**Re: ET Docket No. 13-84  
Response to *Ex Parte* Filing of Sensormatic**

# CIED Manufacturer's position regarding US Patent #5,170,806

Ronald C. Reitan on behalf of  
ISO/TC150/SC6/JWG1/EMC Task Force<sup>1</sup>  
May 3, 2016

FIG. 1

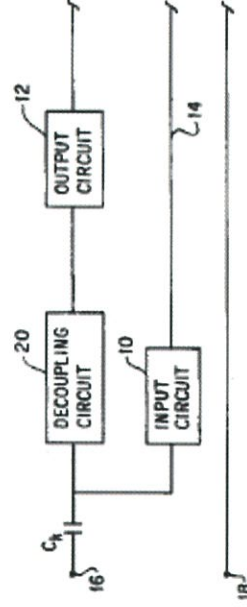
- Adds “decoupling circuit” to isolate pacing output circuit from input stage only during sensing interval

***“Would the technique of this patent significantly improve the EMI immunity of modern CIEDs, especially in the frequency range of 30kHz to 100kHz (where EAS gates manufactured by Sensormatic currently operate)?”***

- Pacing output circuit is not the only contributor to input impedance asymmetry
  - ESD protection of sense amp IC inputs
  - Front-end protection from external defib and electrocautery signals
  - Multiplexor circuits ahead of sense amps that allow various sensing vectors to be selected
  - Blocking FETs and diode protection from ICD outputs
  - The patent does not address asymmetry resulting from the electrochemical nature of the body/lead

- If we were to test the concept of this patent by taking a MRI-compatible modern device and completely removing the connection to the pacing circuitry (i.e. leaving only the sensing circuit connected to the leads), the immunity of the device to 30 kHz to 100 kHz signals would not be significantly improved from that of an unmodified device.

- **Voltage drop in the pacing output path**
  - The energy lost in the decoupling circuit can lead to a clinically meaningful reduction in device lifetime, especially in devices providing continuous therapy

- In variable pacing output devices, following a pacing amplitude change, the implementation could require up to 100 pace pulses before steady state is achieved
  - Manual or automated threshold testing nearly impossible without significant patient risk due to loss of capture

- Significantly impacts<sup>1</sup> other critical CIED functions
  - Evoked response detection for capture verification
  - Impedance measurements for determination of chest cavity fluid (HF monitoring)

- Increase in device volume, reduced reliability
  - IC/monolithic implementation of the design would reintroduce the same body diode asymmetries that are targeted for avoidance
  - Realistic implementation requires use of many new discrete components requiring more hybrid circuit real-estate
  - Higher discrete component count negatively affects reliability

- Additional severe failure modes
  - The output isolation function introduces a number of new potential failure modes
  - Such failures could lead to a cessation of life-sustaining therapy

## Manufacturer's response: NO

- Implementation of the patent in current-generation devices:
  - Will not provide any additional immunity to EAS systems
  - Accrues multiple negative effects upon performance and device characteristics
    - Increased device size
    - Reduced reliability
    - Reduced longevity
    - Reduced clinical effectiveness
    - Increase in patient safety risk
